**Licence Number** L8103/1989/3

**Licence Holder** Aragon Resources Pty Ltd

**Premises** Fortnum Gold Mine  
Mining Tenements – M52/6, M52/95, M52/96, M52/98,  
M52/99, M52/132, M52/133

**Date of Amendment** 26 February 2019

Figure 2: Tom's Pit tailings delivery discharge plan

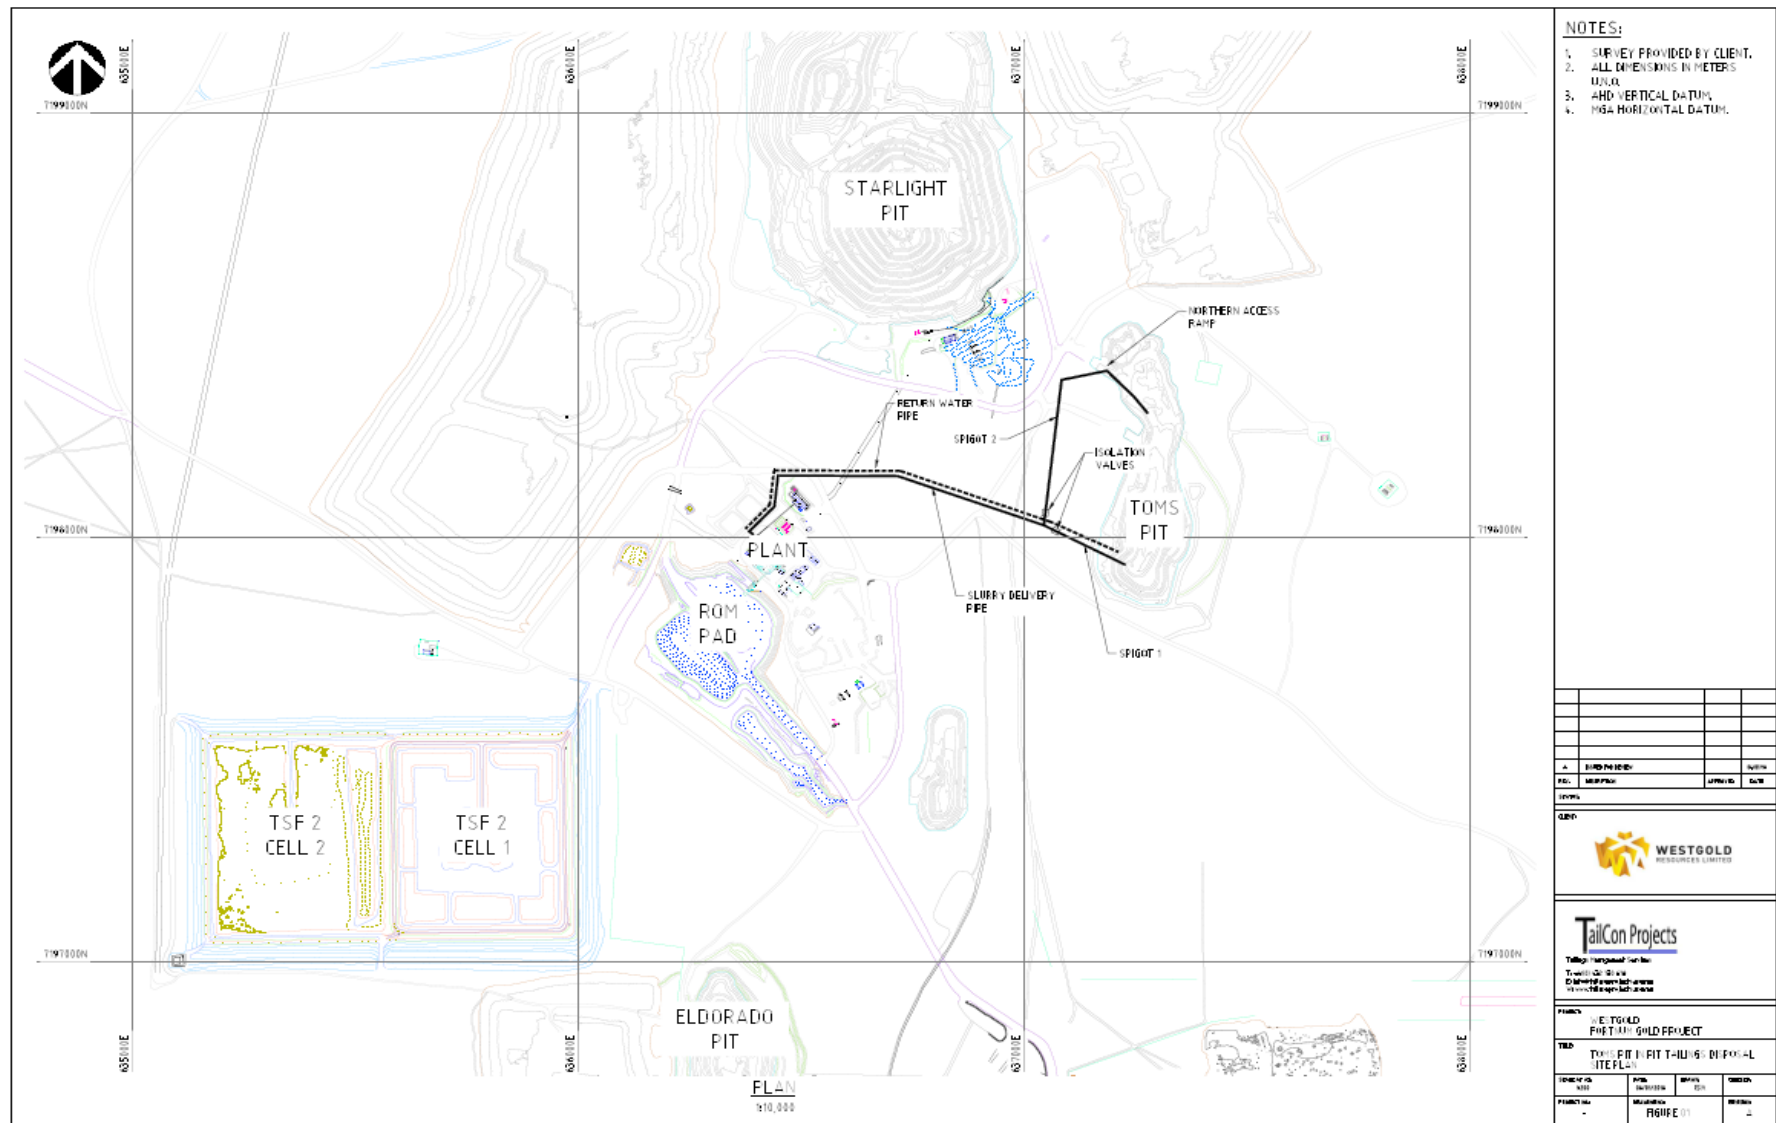
Tailings will be conveyed from the processing plant to Tom's Pit via a new above ground slurry pipeline laid within a constructed bunded corridor. The tailings slurry pipeline will be installed with two single point discharge points at Tom's Pit. Two spigot points will be located at the pit rim and selectively operated to control the decant pond location, facilitating water return to the plant. One spigot point will initially be located in the south western section of the pit. From this location the tailings will beach to the north, moving the pond location northerly as the facility fills. The second spigot point will be located in the north west of the pit – tailings will beach to the south from this location, moving the pool south. The spigot points will be operated as required to manage the decant pond location.

Figure 2 shows the location of the tailings slurry pipeline and spigot points.

8. The Figure below is added to the Attachment 1: TSF Monitoring Bore Location Map as Attachment 1B.

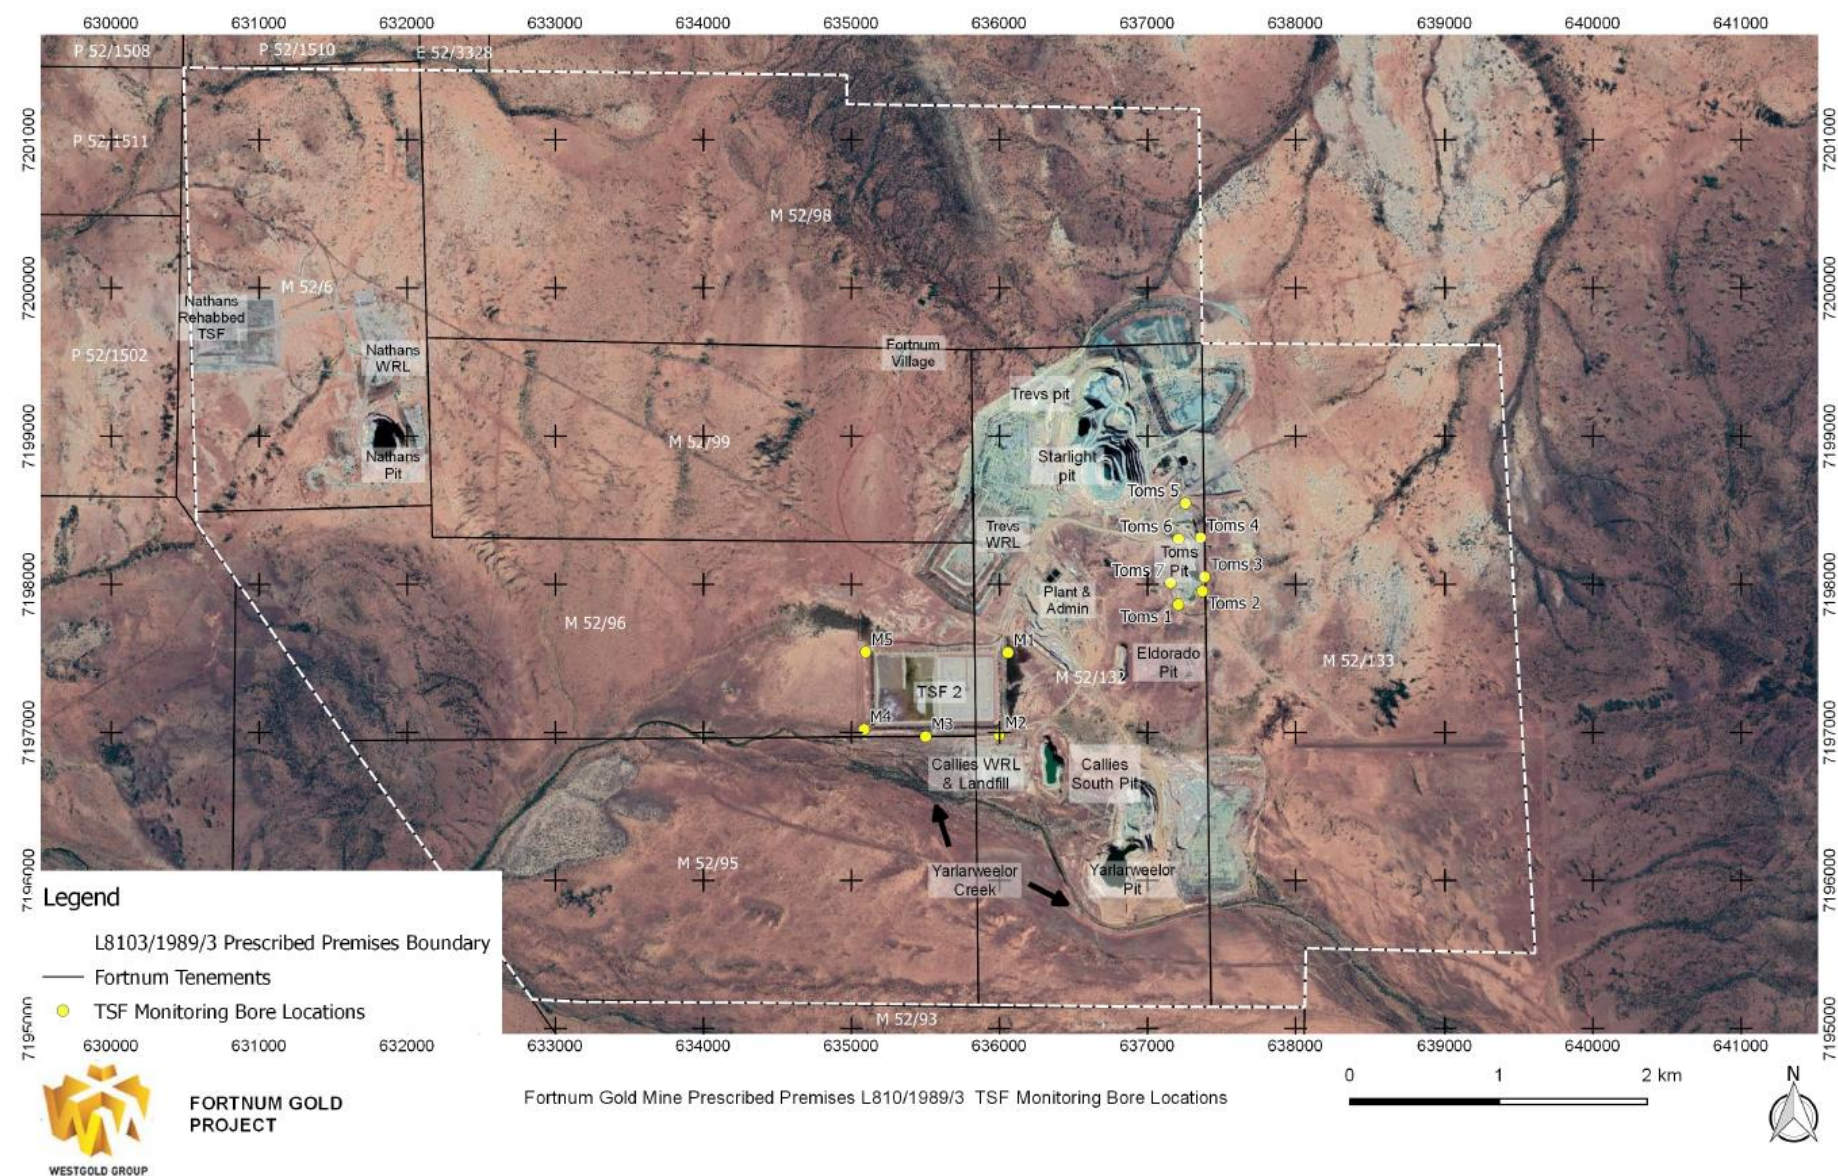
Column 1	Column 2	Column 3	Column 4	Column 5
Monitoring sites	Frequency	Parameters	Units	Limit
<b><u>TSF2 Monitoring bores:</u></b>  FTR246D Junction Bore, FTR266D Creek Bore, M1, M2, M3, M4 and M5	Quarterly (January, April, July, October)	Standing Water Level (SWL)	mAHD	N/A
		pH	N/A	<u>Range 6 to 9</u>
		<u>Major ions – Na, K, Ca, Mg, HCO<sub>3</sub>, SO<sub>4</sub>, Cl</u>	<u>mg/L</u>	<u>N/A</u>
		<u>Nitrate-nitrogen (NO<sub>3</sub>-N )</u>	<u>mg/L</u>	<u>N/A</u>
		Total Dissolved Solids (TDS)	mg/L	<u>4000 mg/L</u>
		<u>Cyanide (total)</u> <u>Weak Acid Dissociable-Cyanide (WAD-CN)</u>	mg/L	<u>0.8 mg/L</u>
		Arsenic (As) Antimony (Sb) <u>Boron (B)</u> Cadmium (Cd) Chromium (Cr) - <u>including hexavalent chromium (Cr VI)</u> Cobalt (Co) Copper (Cu) Iron (Fe) Lead (Pb) <u>Manganese (Mn)</u> <u>Mercury (Hg)</u> Nickel (Ni) Selenium (Se) Thallium (Tl) Zinc (Zn)	mg/L	N/A
<b><u>Toms In-Pit TSF:</u></b> <u>Toms 1</u> <u>Toms 2</u> <u>Toms 3</u> <u>Toms 4</u> <u>Toms 5</u> <u>Toms 6</u> <u>Toms 7</u>	<u>Monthly</u>	<u>Standing Water Level (SWL)</u>	<u>mAHD</u>	<u>N/A</u>

**Attachment 4: Dewater pipeline and discharge locations (Starlight, Callie's South, Eldorado and Trev's Pits)**

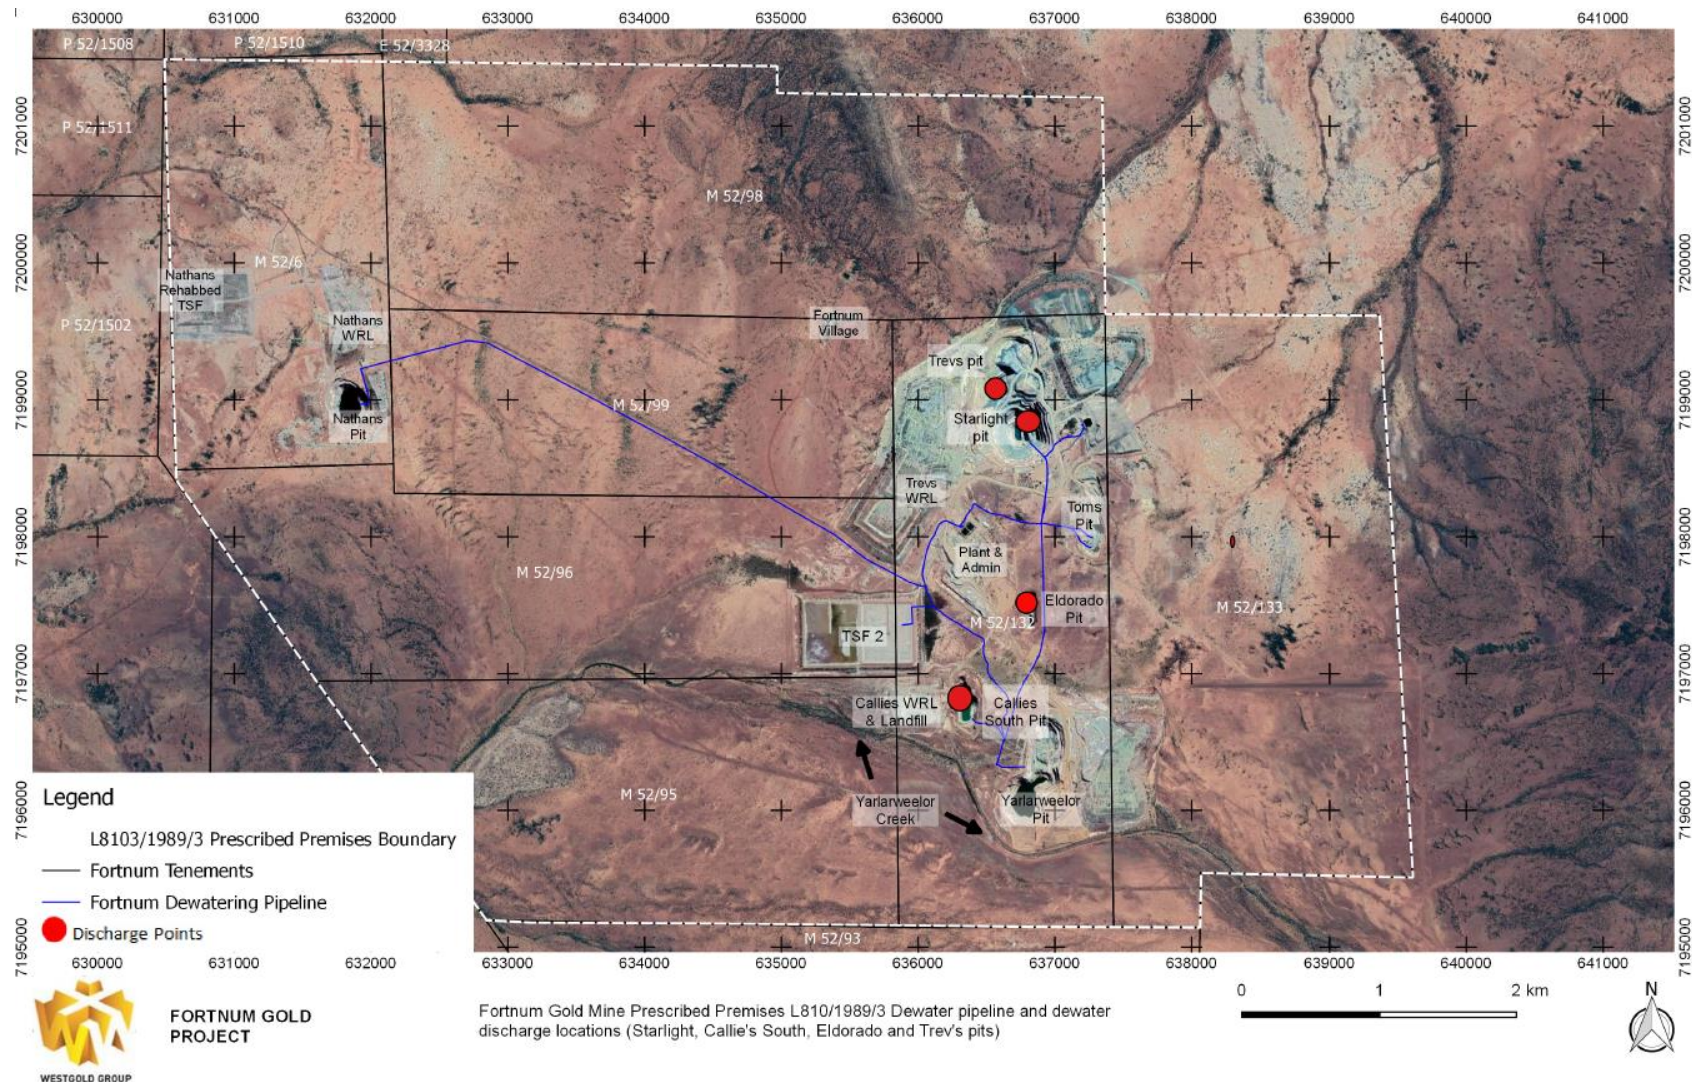
9. Attachment 4 (as listed as Figure 2 in Amendment Notice 2 of the Licence) is replaced with the new Attachment 4 as shown below.
